Safety Evaluation Report

related to the operation of
River Bend Station

Docket No. 50-458

NUREG-0989
Supplement No. 1

Figure 2.1 Single-unit layout for River Bend Station

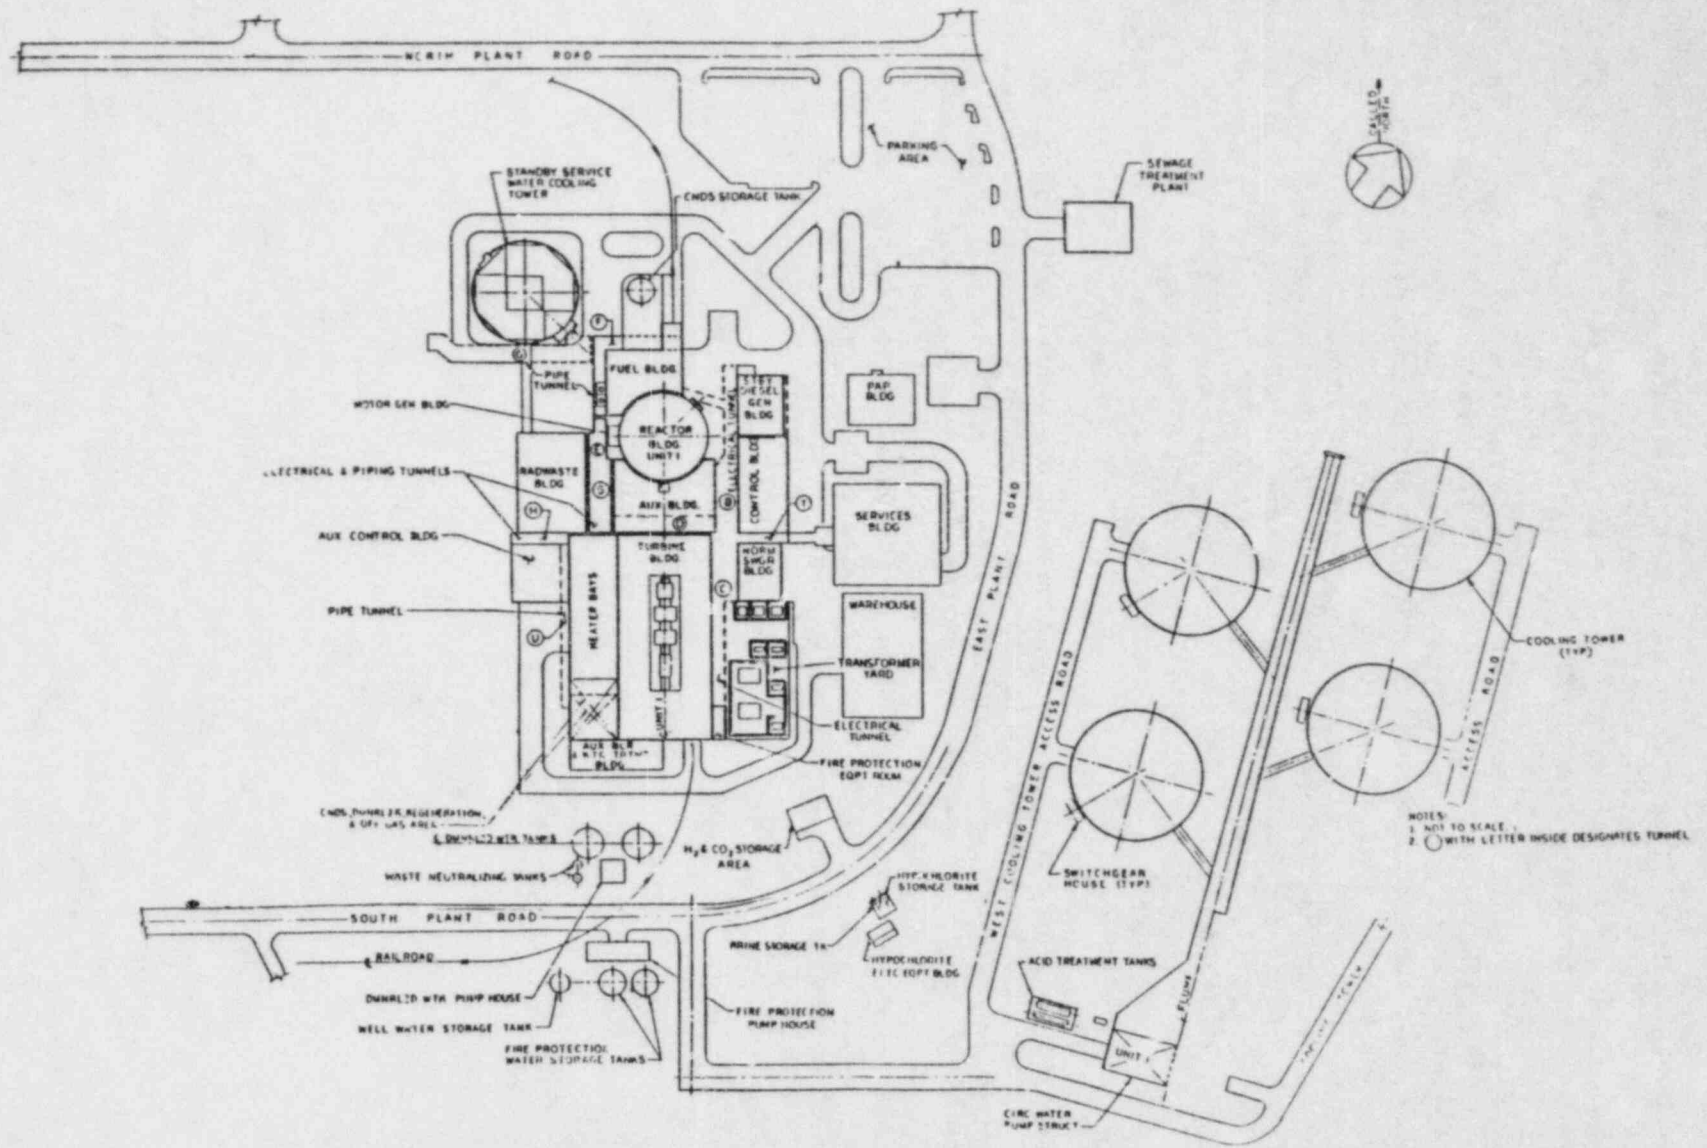
At the time of publication of the SER, only a two-unit plant layout drawing was available and the staff stated that a single-unit layout drawing would be included in a supplement to the SER. Figure 2.1 below shows the single-unit plant layout for River Bend Station.

Figure 17.2 River Bend QA organization

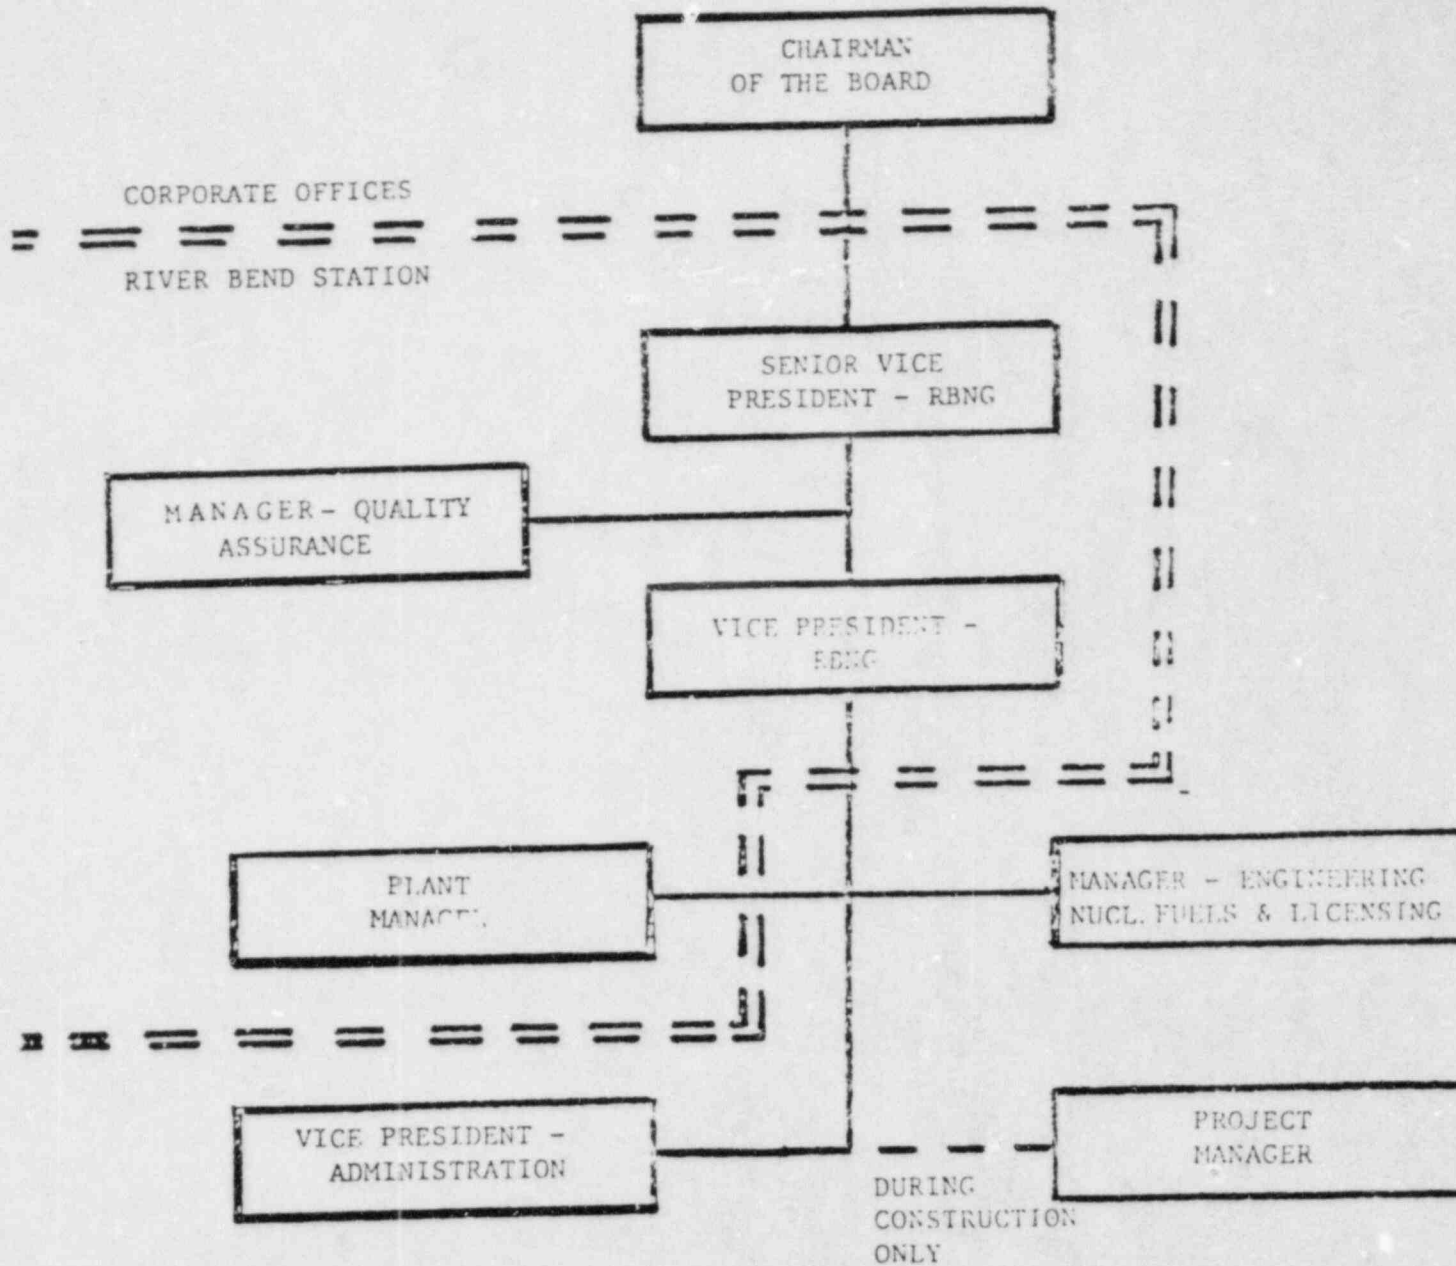
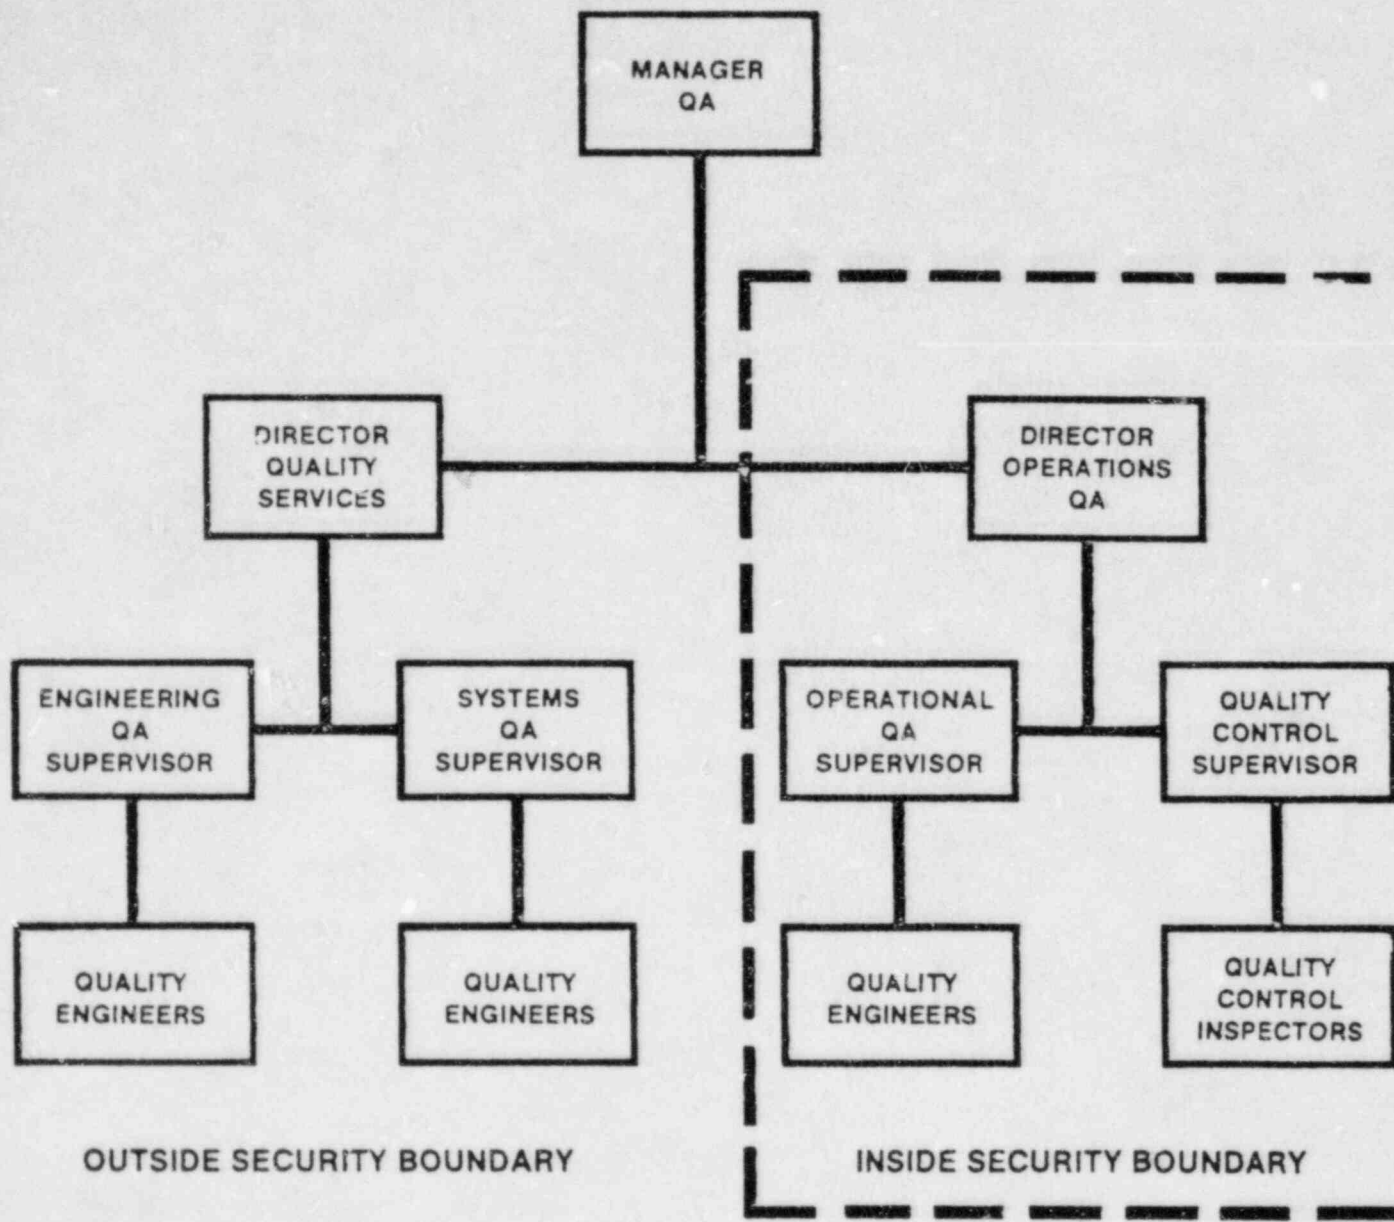
In the SER the staff reported that changes had been made in the River Bend Station Quality Assurance (QA) organization about the time of issuance of the SER. According to the applicant, the changes were administrative in nature. As a result, in the SER the staff identified a confirmatory issue requiring additional staff review of the QA organization to verify that this reorganization was administrative and that the staff's evaluation in the SER remained valid.

The staff has completed its review of the QA organization as reflected through FSAR Amendment 13 and confirms that the changes are acceptable. The administrative changes include the change in title of the Director-Quality Assurance to Manager-Quality Assurance, and a change in the QA Department staff reporting to the Manager-Quality Assurance. The Manager-Quality Assurance is now assisted by the QA Department staff, which consists of Quality Systems, Operational QA, Quality Engineering, and Quality Control. As discussed in the SER, the Manager-Quality Assurance has delegated the responsibility for the QA program during operation to the Operational Quality Assurance Supervisor (OQAS). However, as a result of the administrative changes, the OQAS now evaluates and reports the status and adequacy of the quality assurance program at the station to the Director-QA, the Manager-Quality Assurance, and, on a periodic basis, to the Plant Manager. The administrative and functional reporting organization is shown in the revised version of Figure 17.1 below. The revised QA organization is shown in the revised version of Figure 17.2 which follows. This resolves Confirmatory Issue (64).
